City Project No.: 14-30

Addendum No.: 2

FOR CONSTRUCTION ON
Project No: 14-30
Sewer Line Replacement on Angelus Street, Bothun Road, and Castor Street

SHEET
9
OF 16

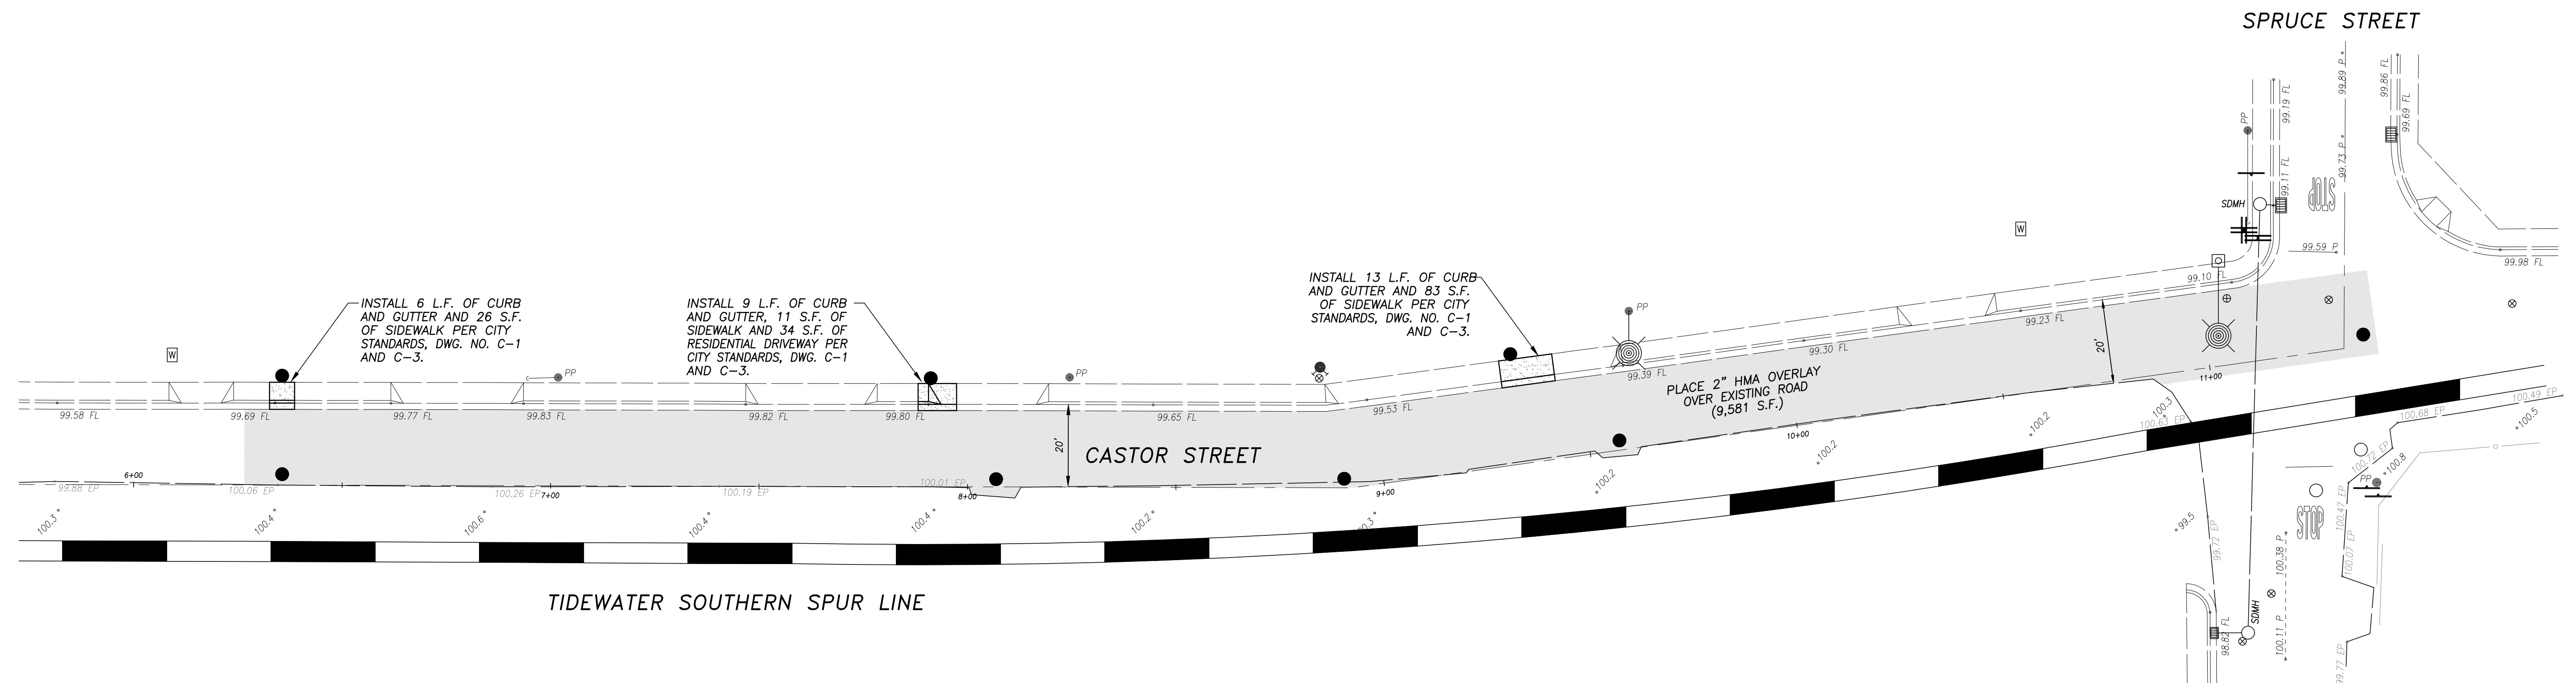
6. Sheet 9 and Sheet 10

The existing 16-inch pipe material is assumed to be clay. Remove and replace sheet 9 with the attached sheet. New pipe material is 18" SDR-26 on bid item 11.
